RECOMMENDED SERVICE BULLETIN**SUBJECT:** SB16-02**REVISION:** 00**DATE:** 02/17/2016**EFFECTIVITY:** KODIAK 100 Series Airplane Serial Numbers 100-0086 thru 100-0110 or airplanes subsequently equipped with the Flap Gearbox Controller (also referred to as "Gearbox/Controller") and/or Aileron Trim Actuators listed in FSI-129.**SUMMARY**

TITLE: Flap Gearbox Controller and Aileron Trim Actuator Replacement

REPORT NO.: FSI-129

Figure 3-1: Overview

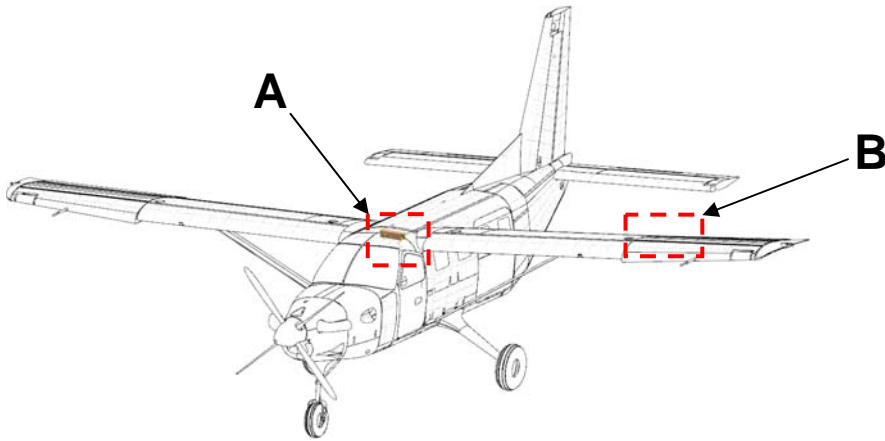
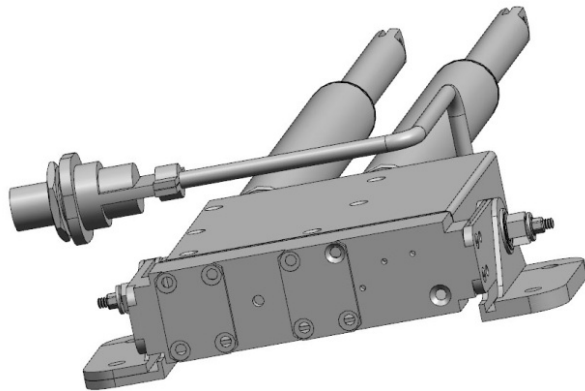
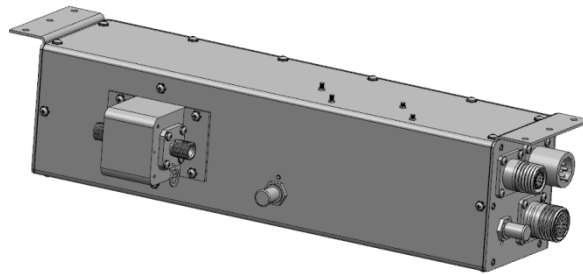
Suspect gears were installed in the Gearbox/Controller (P/N 100-621-0113) and Aileron Trim Actuator (P/N 100-624-0100). The over-hard gears installed in the Gearbox/Controller are used in a location of low torque, and no functional issue is expected to occur. The over-hard gears installed in the Aileron Trim Actuator might eventually cause the actuator to exhibit one of the symptom listed above. Quest recommends that suspect Gearbox/Controllers or Aileron Trim Actuators be sent back to Quest.

The Gearbox/Controller is located between the wings, in the passenger cabin, and above the headliner. See **Figure 3-1, Detail A**.

The aileron trim actuator is located in the left wing. See **Figure 3-1, Detail B**.

5.1 Replace Gearbox/Controller

1. Remove the Gearbox/Controller in accordance with AM902.0, *KODIAK 100 Airplane Maintenance Manual*, Chapter 27.
2. Install the replacement Gearbox/Controller unit in accordance with AM902.0, *KODIAK 100 Airplane Maintenance Manual*, Chapter 27.

5.2 Replace Aileron Trim Actuator

1. Remove the Aileron Trim Actuator in accordance with AM902.0, *KODIAK 100 Airplane Maintenance Manual*, Chapter 27.
2. Install the replacement Aileron Trim Actuator unit in accordance with AM902.0, *KODIAK 100 Airplane Maintenance Manual*, Chapter 27.
3. Return the affected part to Quest Customer Service.
